EMS STATION RENOVATIONS**ADDENDUM NO. 2****EAST RALEIGH EMS STATION 7**

WAKE COUNTY REQUEST FOR BIDS NUMBER: RFB #26-082

DATE: **SEPTEMBER 10, 2026****BID DATE, TIME, AND LOCATION HAVE NOT BEEN CHANGED.**

SHEET: 02-M601

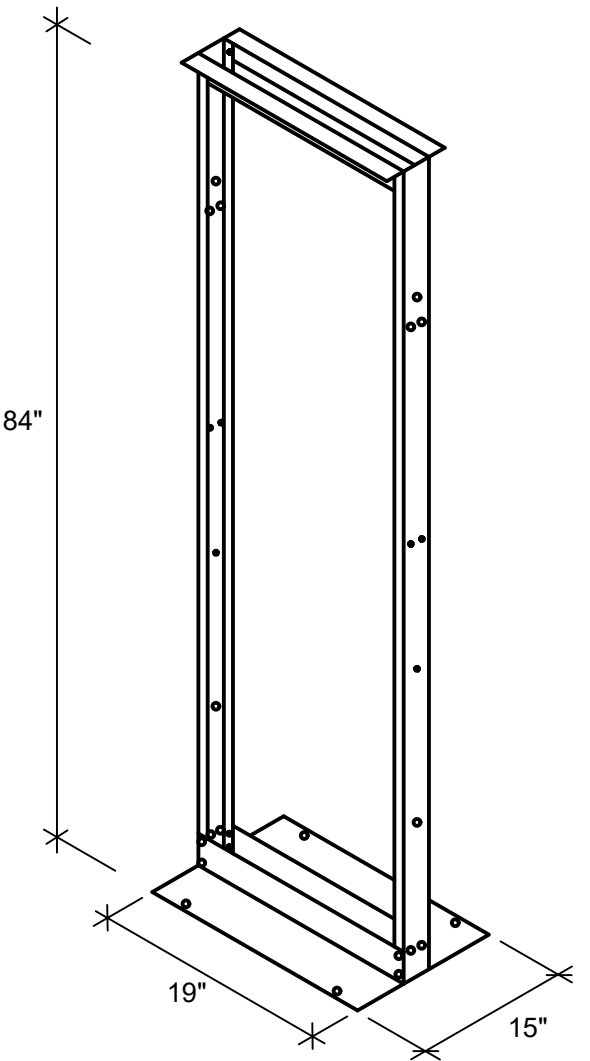
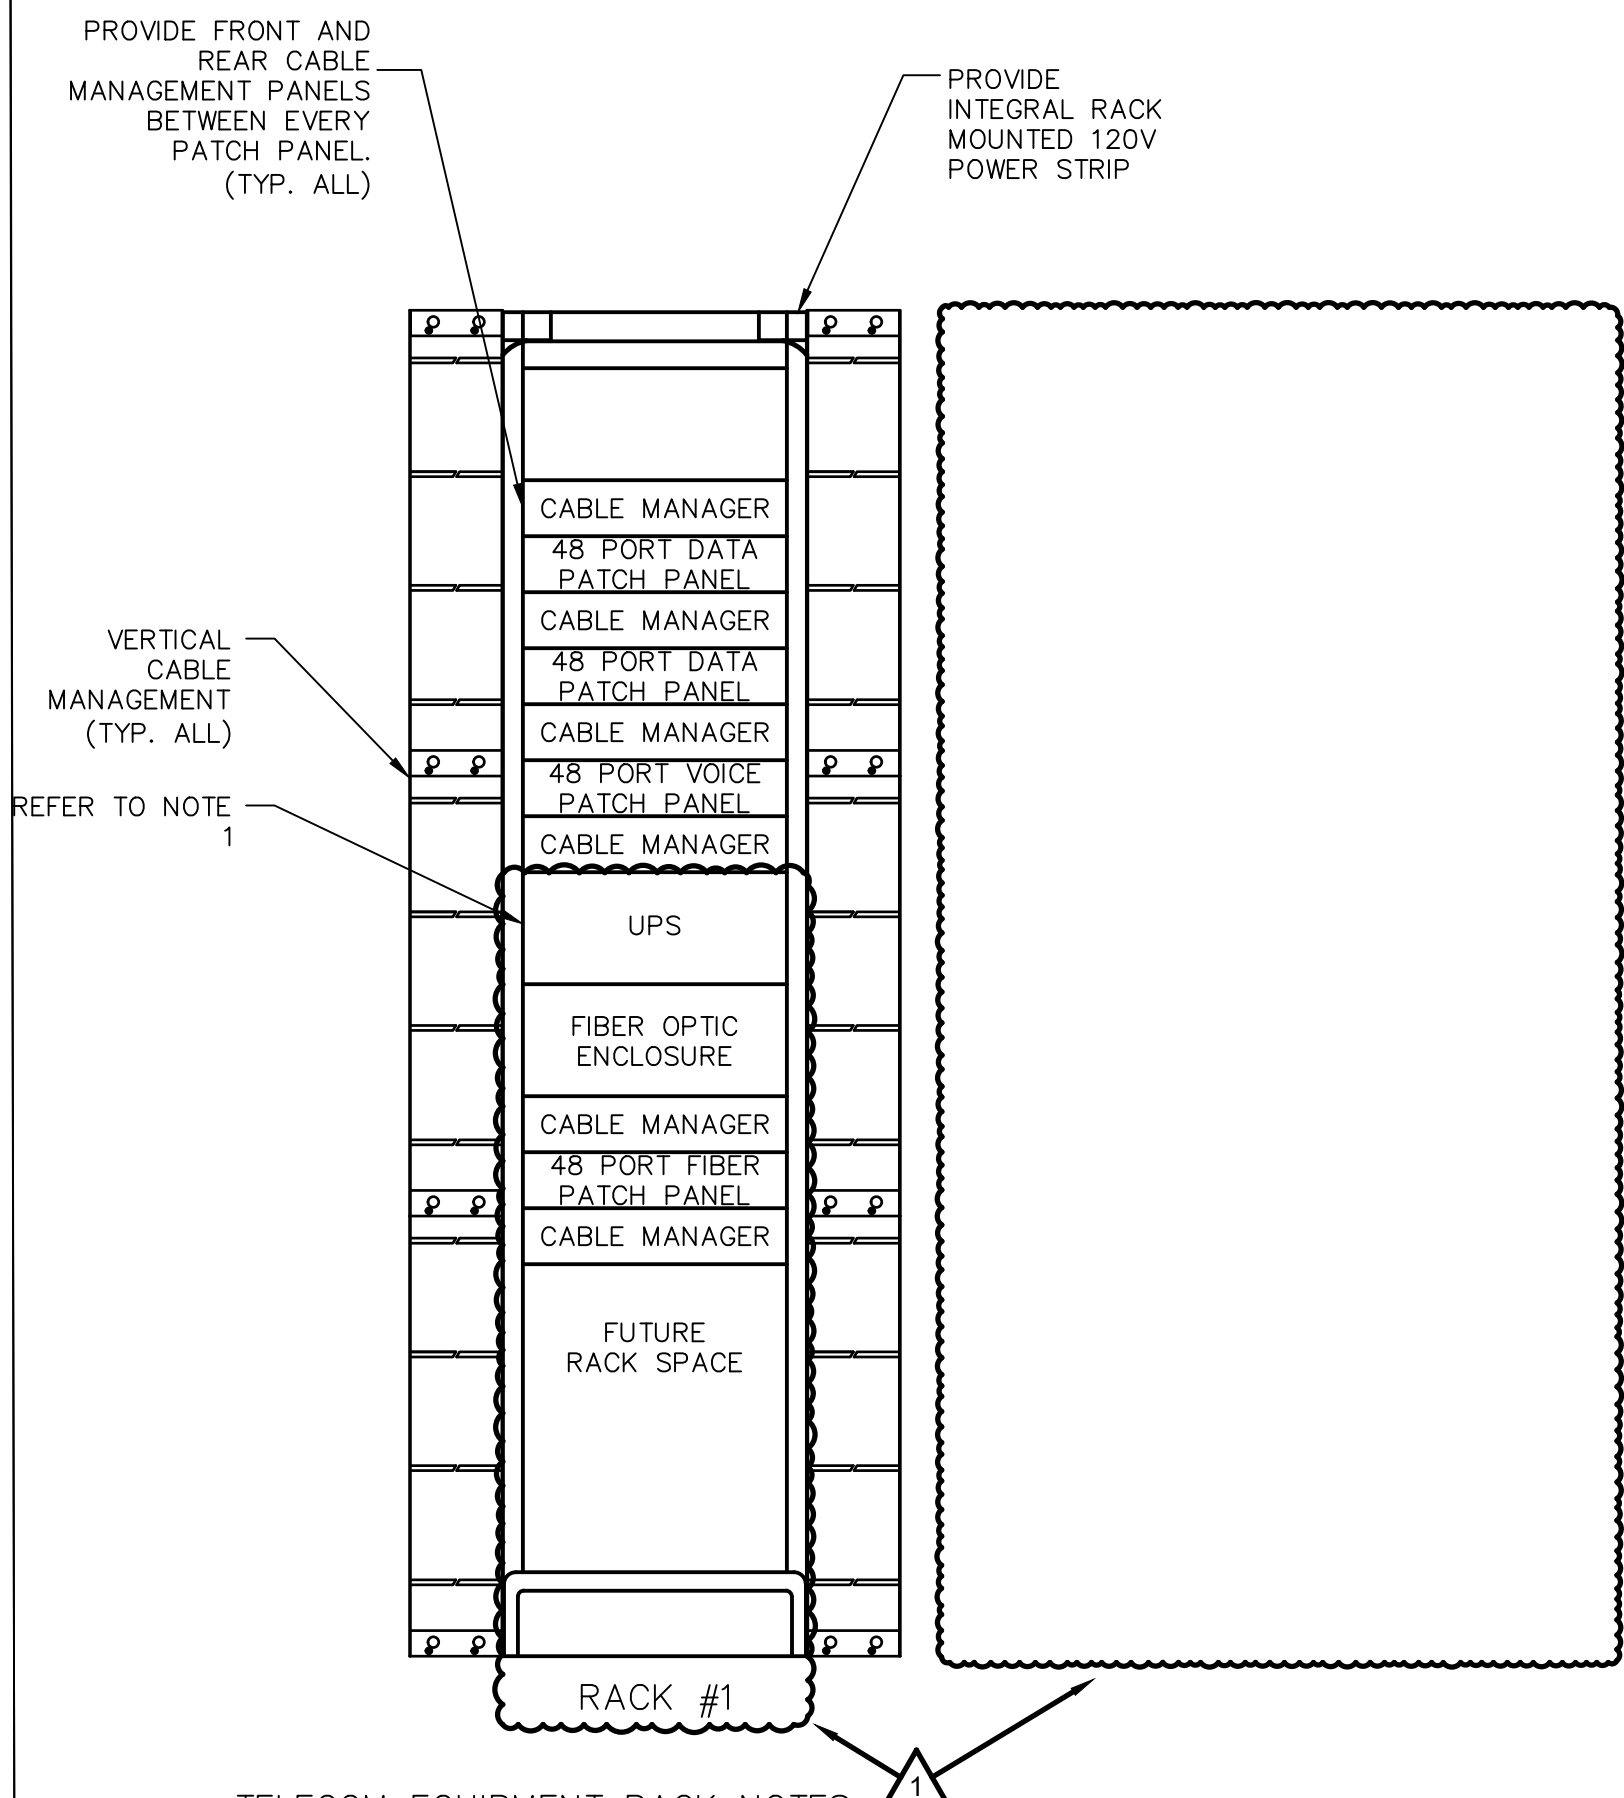
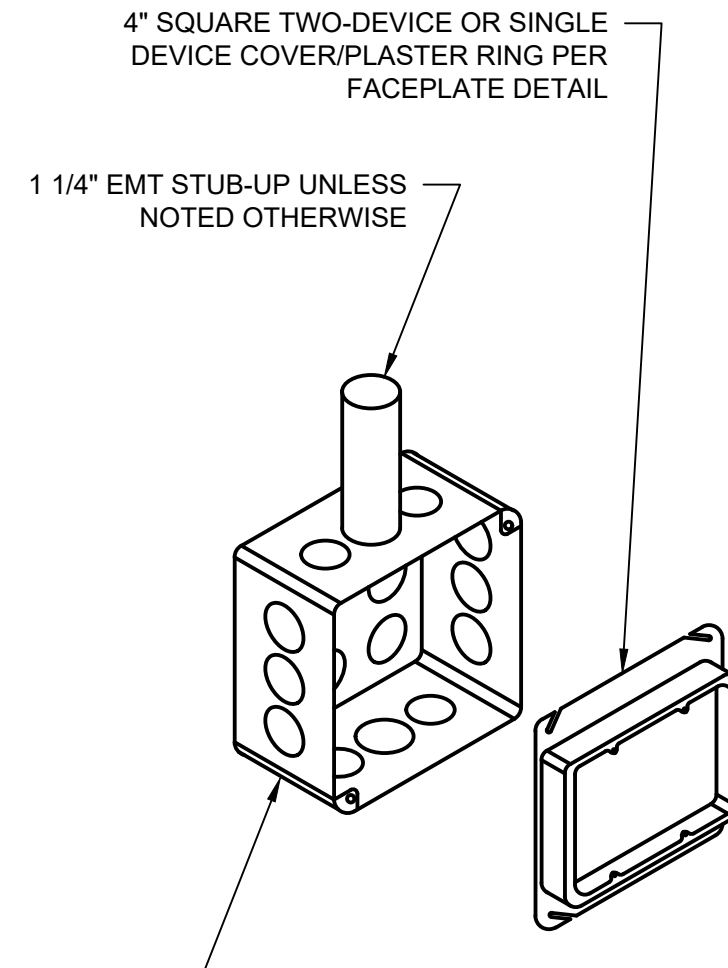
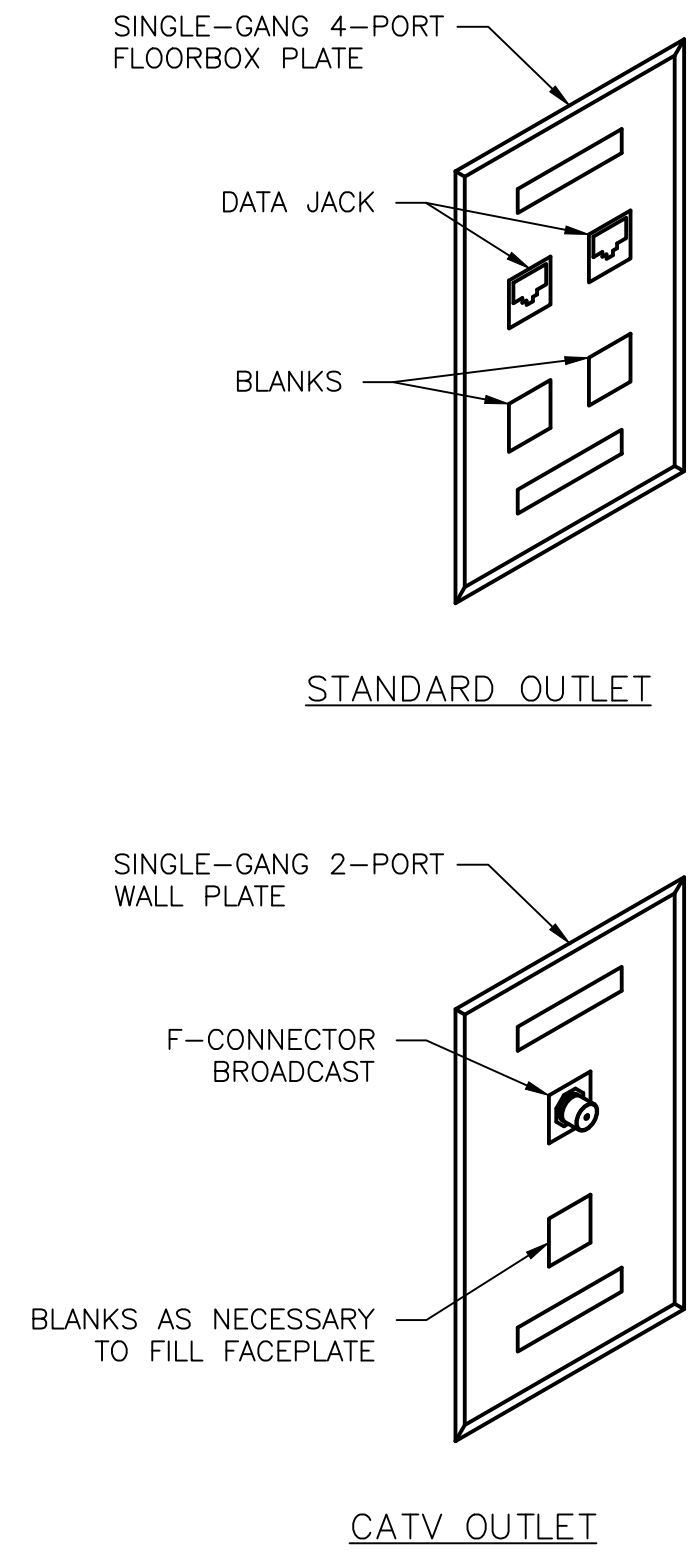
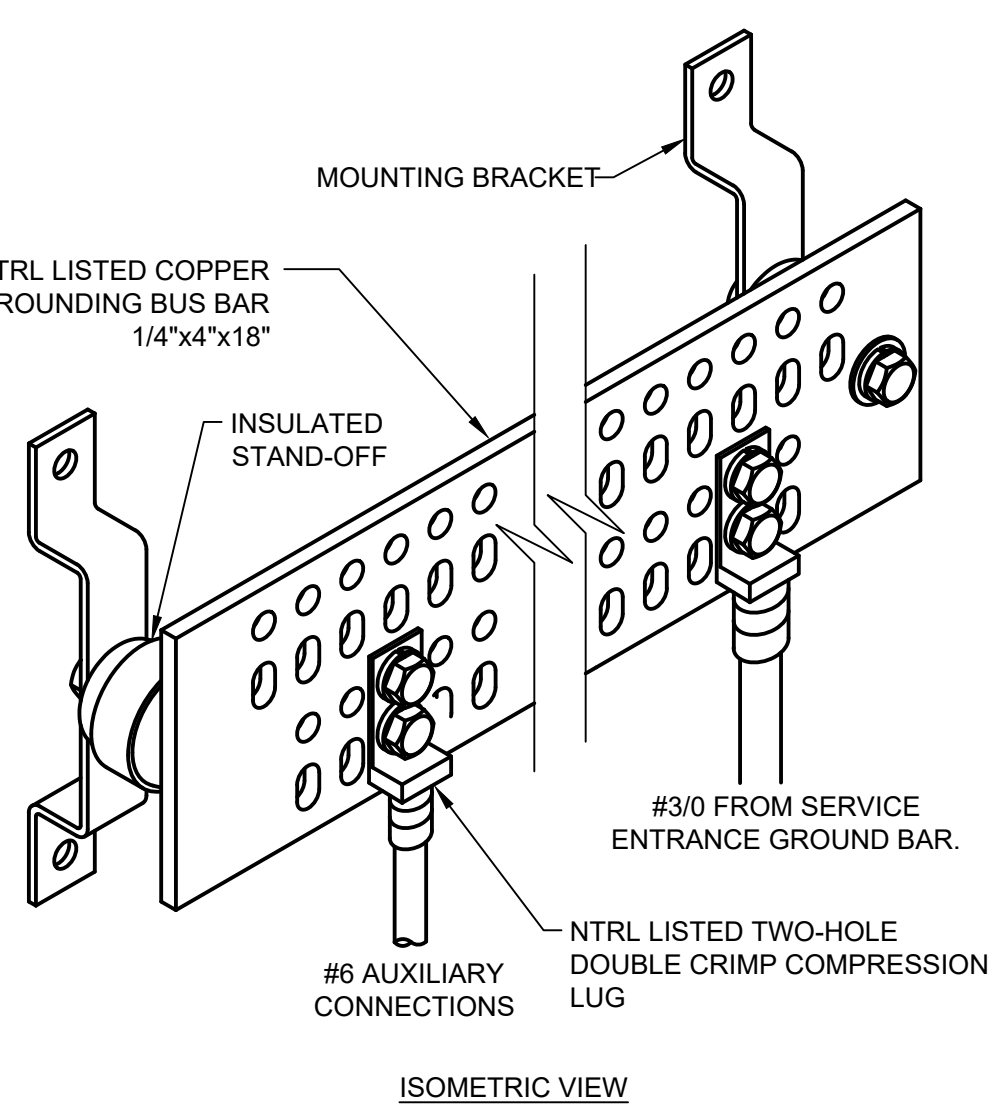
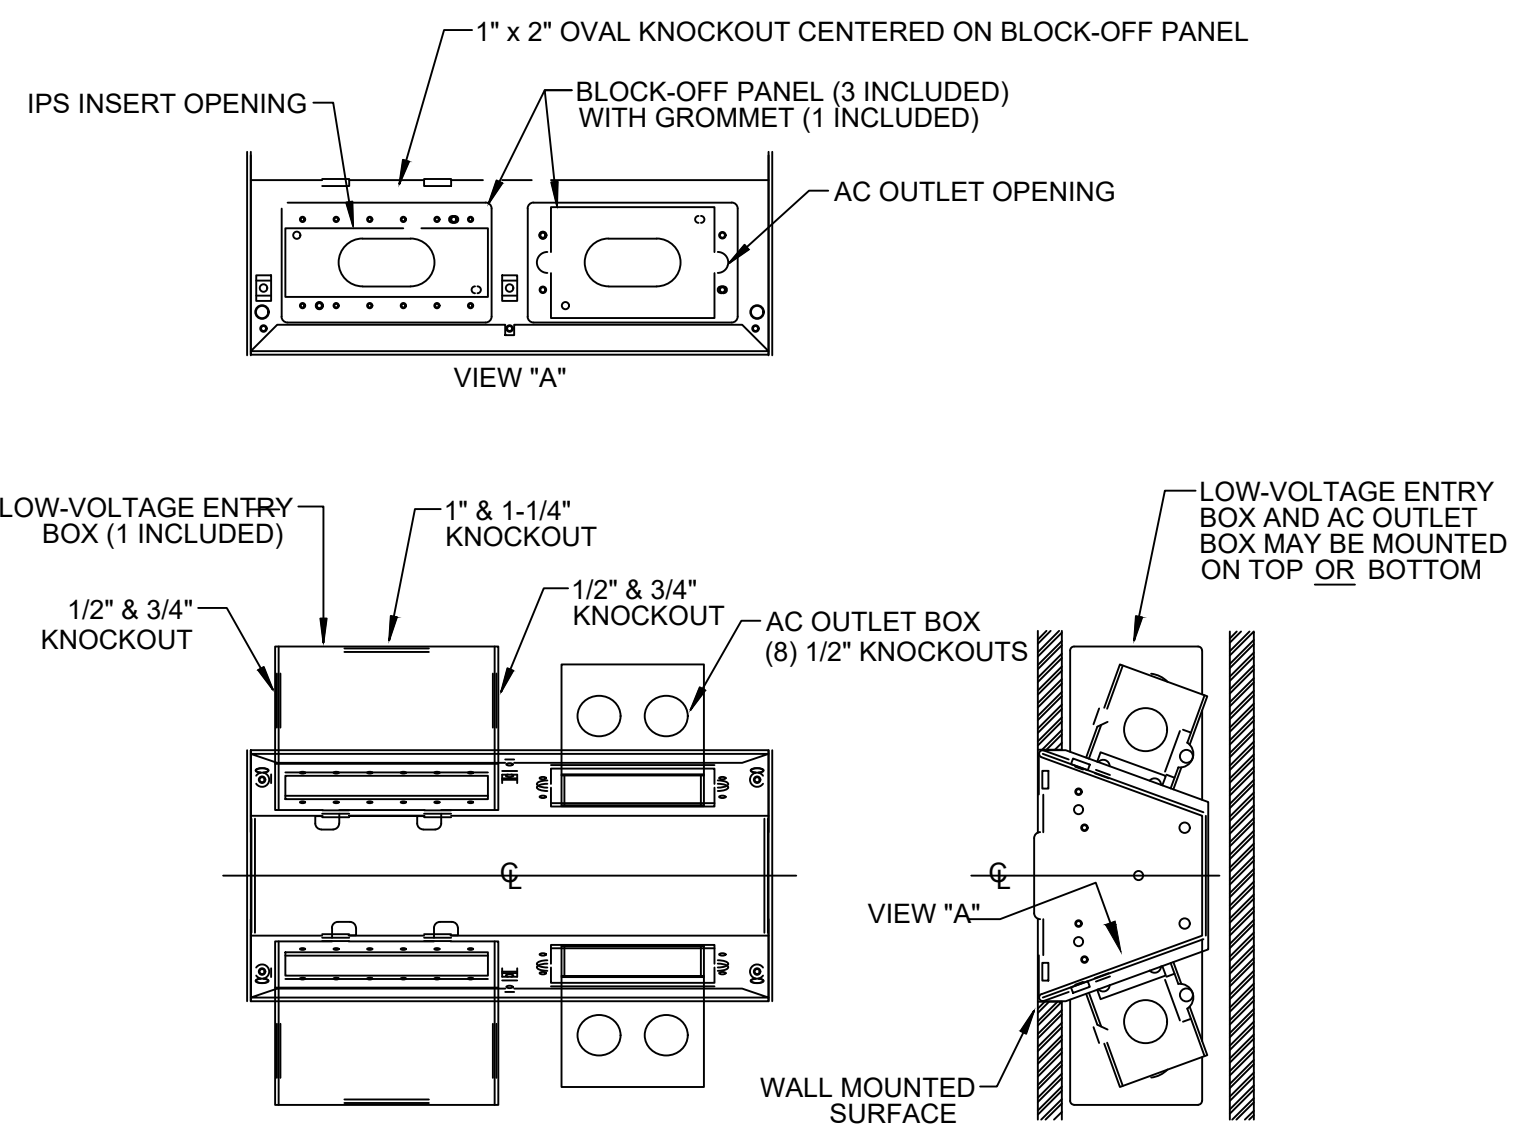
1. **REPLACE** Sheet 02-M601 – Schedules with the attached, updated 02-M601 – Schedules (Revision 1, Dated 09/10/26). DMMS-8-1 Refrigerant Calculations added. DMMS-8-1 tonnage updated, and refrigerant leak mitigation added.

SHEET: 02-E502
	1	2	3	4	5	6	7	8	9	10	11	12	13	14	DATE 7/31/2026

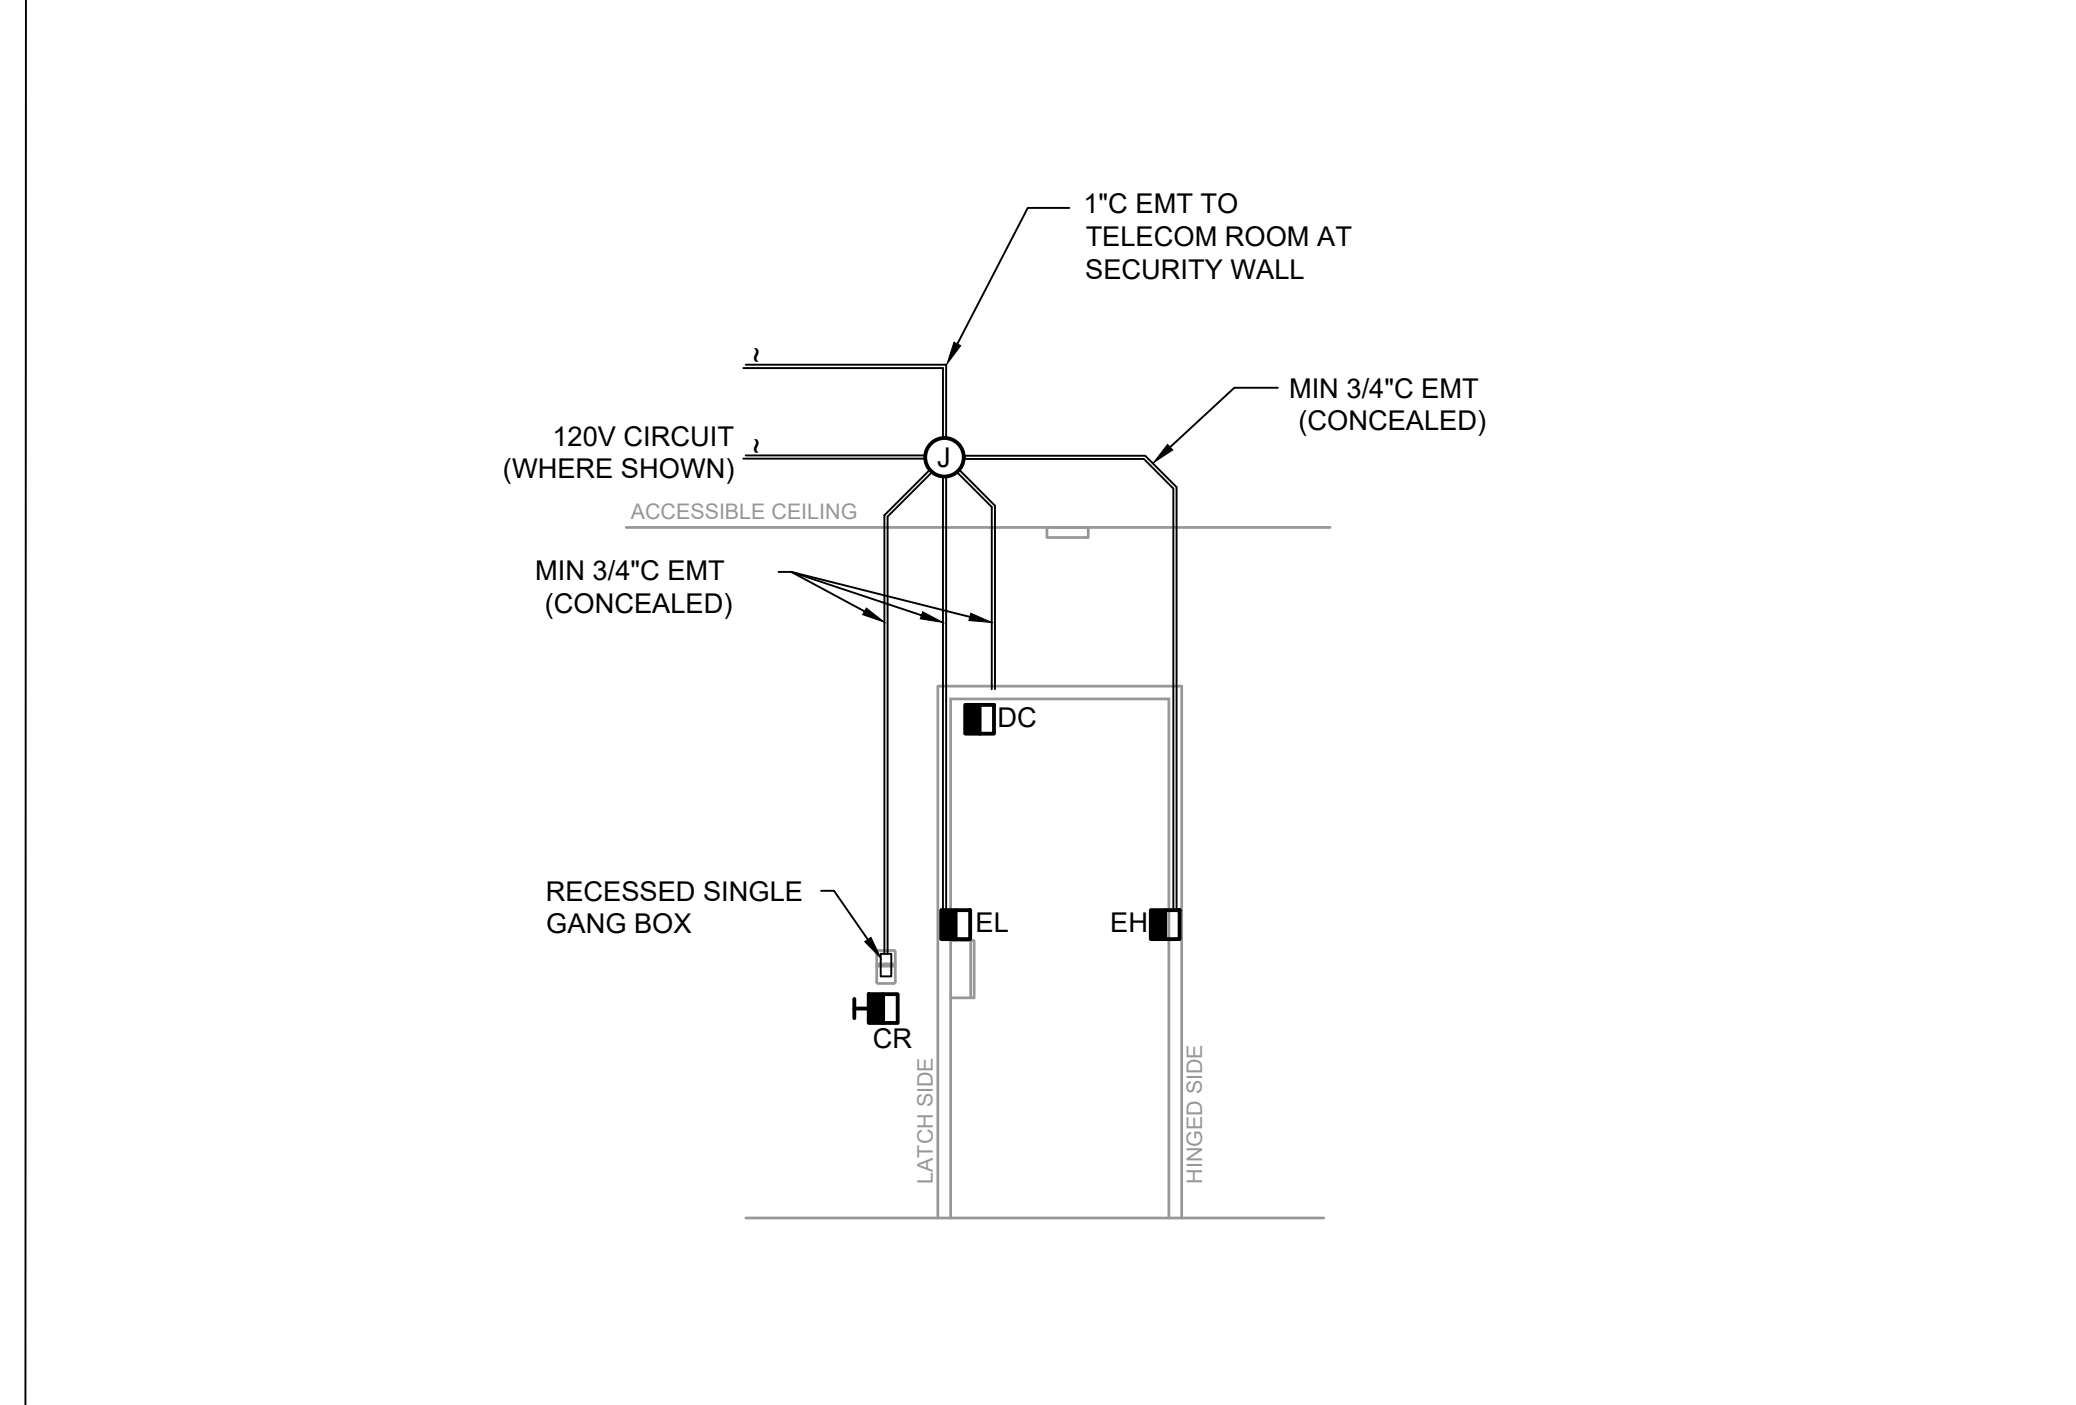
1. **REPLACE** Sheet 02-E502 – Details with the attached, updated Sheet 02-E502 – Details (Revision 1, Dated 09/10/26). Telecom Equipment Rack Elevation detail updated.
